Form C-103
Revised July 18, 2013

WELL API NO. 30-015-10286
5. Indicate Type of Lease STATE <input checked="" type="checkbox"/> FEE <input type="checkbox"/>
6. State Oil & Gas Lease No.
7. Lease Name or Unit Agreement Name Resler Yates State
8. Well Number #368
9. OGRID Number 154329
10. Pool name or Wildcat (3230) Artesia; Queen-Grayburg-San Andre s

SUNDRY NOTICES AND REPORTS ON WELLS
(DO NOT USE THIS FORM FOR PROPOSALS TO DRILL OR TO DEEPEN OR PLUG BACK TO A DIFFERENT RESERVOIR. USE "APPLICATION FOR PERMIT" (FORM C-101) FOR SUCH PROPOSALS.)

Operator: MEWBOURNE OIL CO P.O. Box 5270 Hobbs, NM 88241	OGRID: 14744
	Action Number: 524501
	Action Type: [C-103] NOI Plug & Abandon (C-103F)

Well Name: Resler Yates State #368

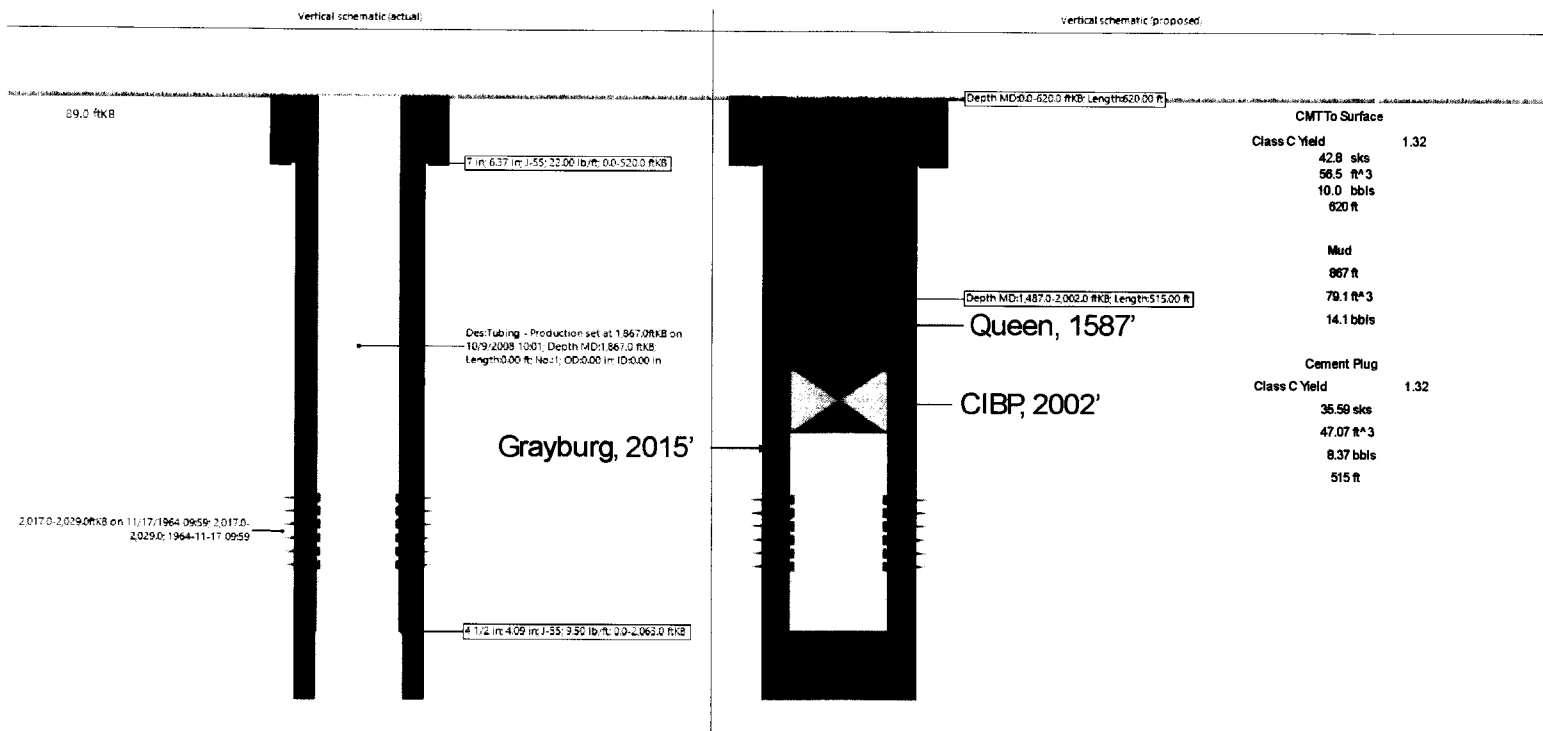
Created By	Condition	Condition Date
loren.diede	Notify the OCD inspection supervisor via email 24 hours prior to beginning Plug & Abandon (P&A) operations.	11/14/2025
loren.diede	NMOCD does not consider this well to be within the LPCH restricted area and an above ground P&A marker is required. NMOCD requires that plug(s) be added to cover the 7 Rivers = (970') and Yates = (600') formation tops. Submit photo and GPS coordinates of the P&A marker with the final P&A reports. The API# on the marker is to be clearly legible. Run CBL from CIBP to surface. Submit the CBL tif file to NMOCD for uploading into the Well Log File.	11/14/2025
